**Structural Condition of Chander Kunj Army Towers (CKAT) at**

**Silver Sand Island, Vytilla, Kochi**

**(IITM Report-4)**

**Figure 7 Fire-fighting system pipes passing through the beams**

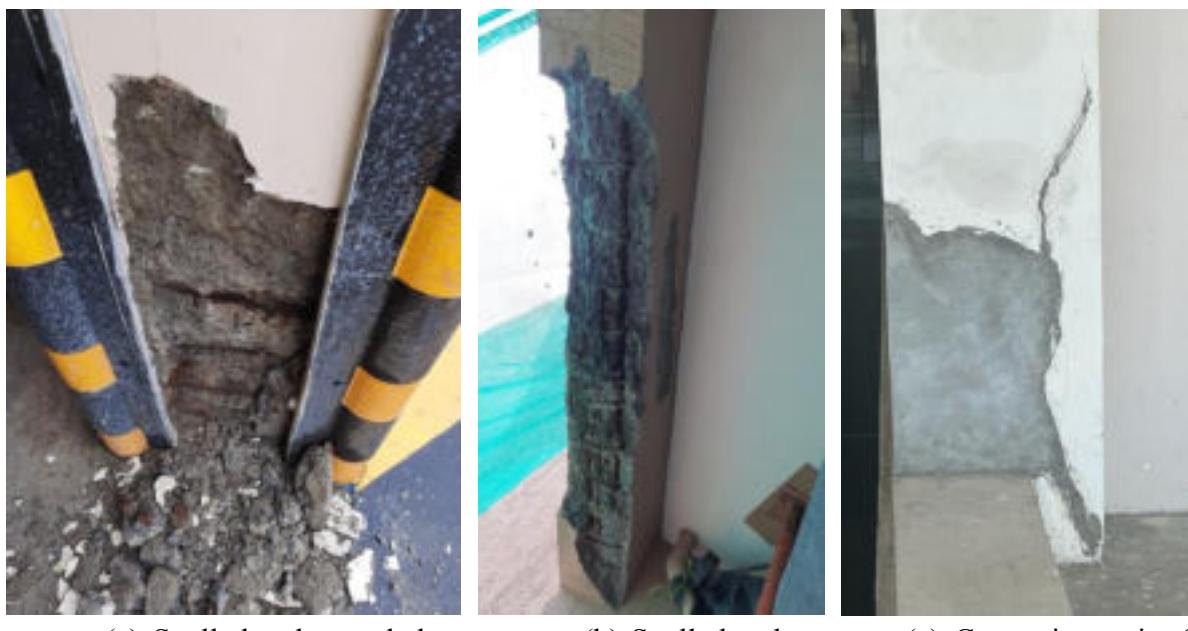
- 3.2 Columns, shear walls, and beams in the basement were found to be severely corroded causing extensive cracking and spalling of concrete (see Figure 4 and Figure 5). Most of the corbels have also suffered significant damage and it was found that multiple patch repairs were done, see Figure 6. In several long-span and deep beams, metal pipes (red-painted; for fire-fighting system) pass through the bottom portions of beams, the consequences of which must be checked by a structural consultant (see Figure 7).

**Figure 12 Inappropriate patch repair of damaged region in shear walls near the elevators (this should not have been done this way)**

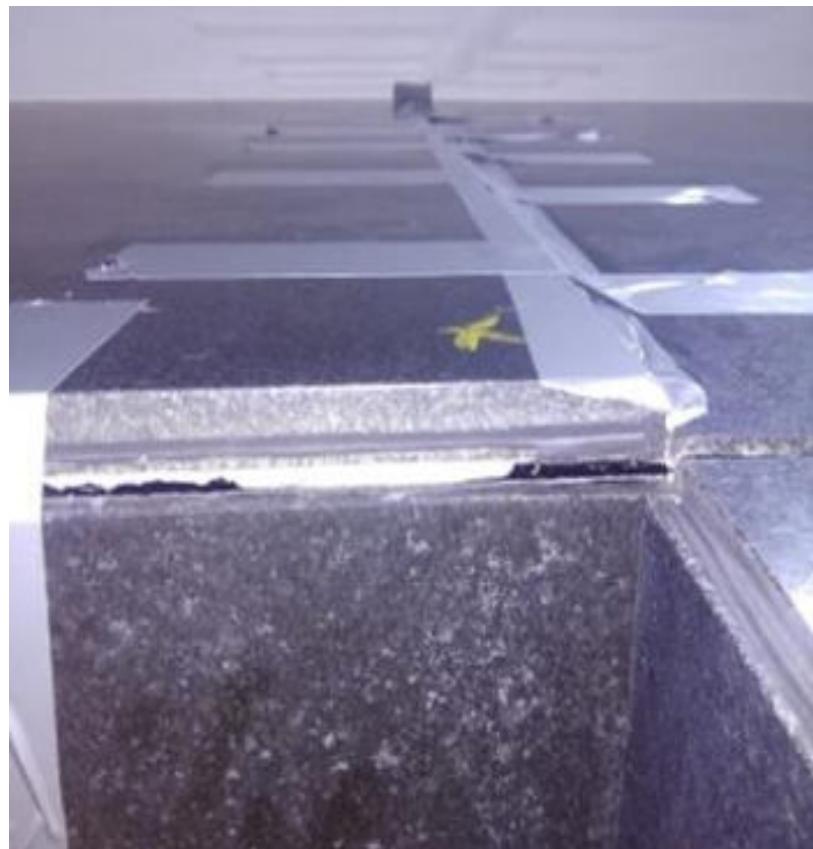
- 3.4 De-bonding of heavy granite panels/wall claddings on the shear walls near the lifts/elevators was observed in all the floors. This is a severe falling hazard and a serious safety concern. This poses high risk to the users, as all the occupants would wait and/or pass below these granite panels. As shown in Figure 13 & Figure 14, it is surprising to see that numerous of these heavy granite panels are affixed with duct-tape, which is not adequate to safely carry their weight and hold them in place, if fully de-bonded. Figure 11 Severely corroded rebars, loose concrete and inadequate filling of mortar between the cladding and the walls were seen upon removal of the claddings (See Figure 11). It was found that the damaged regions in the shear walls were inappropriately patch repaired at multiple locations near the elevators (See Figure 12).

**Figure 18 Extensive cracking and spalling of concrete in staircases**

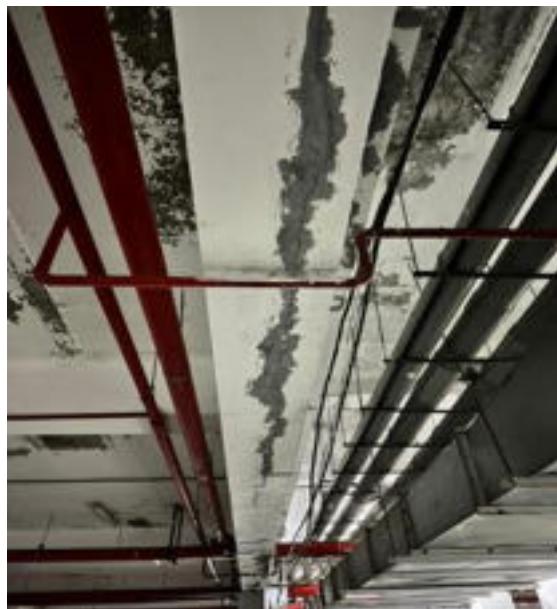
- 3.6 Tenting, popping-up and cracking of floor tiles in the landing of staircases was observed at various locations in multiple floors (see Figure 17). Also, extensive cracking and spalling of concrete were visible on the waist slab, landing beam & slab of staircases in most of the floors (see Figure 18). Further, cracks were observed in the

**Figure 1 Ongoing corrosion in the repaired beam in the basement**

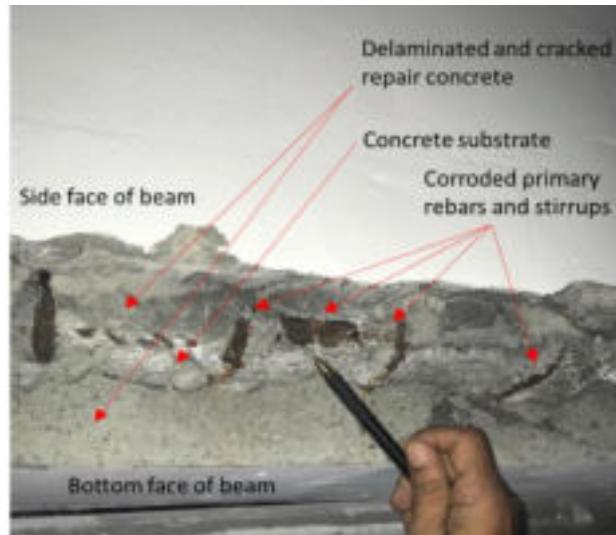
In the presence of the RWA authorities, walk-through inspections of Towers B and C were conducted. Severe corrosion-induced cracking of structural elements, associated patch repairs (repeated patch repairs at same locations, as informed by tenants), signs of leakages etc. were observed. As a particular case and to confirm the corrosion condition, the cracked/delaminated location of one of the long beams in the basement was autopsied (i.e., delaminated cover concrete was removed using a hammer and chisel). This region was found to be an already repaired region and significant steel rust/corrosion products were observed (see Figure 1).

This cracking and delamination might have occurred because the prior repair could not arrest the corrosion of the primary reinforcement and stirrups. This is due to the possible presence of sufficient chlorides in the concrete in contact with the steel. As informed and observed, it seemed that the repair was done by covering the substrate concrete and steel using repair concrete (without any undercutting and electrochemical treatments). The lack of coarse aggregates in this repair concrete indicated that this was possibly microconcrete. Such patch repairs with microconcrete and without undercutting and electrochemical treatments cannot

control corrosion due to (i) the residual chloride effect and (ii) the halo effect. The residual chloride effect is due to the possible chlorides in the substrate concrete and the inadequately cleaned steel surface/rust present and the halo effect is due to the difference in the chemistry between the repair and substrate concretes. The microconcrete was about 2-inch thick, which seemed more than required cover thickness for such members. Also, non-metallic mesh for confinement was observed at the side faces (it seemed that mesh was not present at the bottom face), questioning the effectiveness of mesh in confining the concrete.
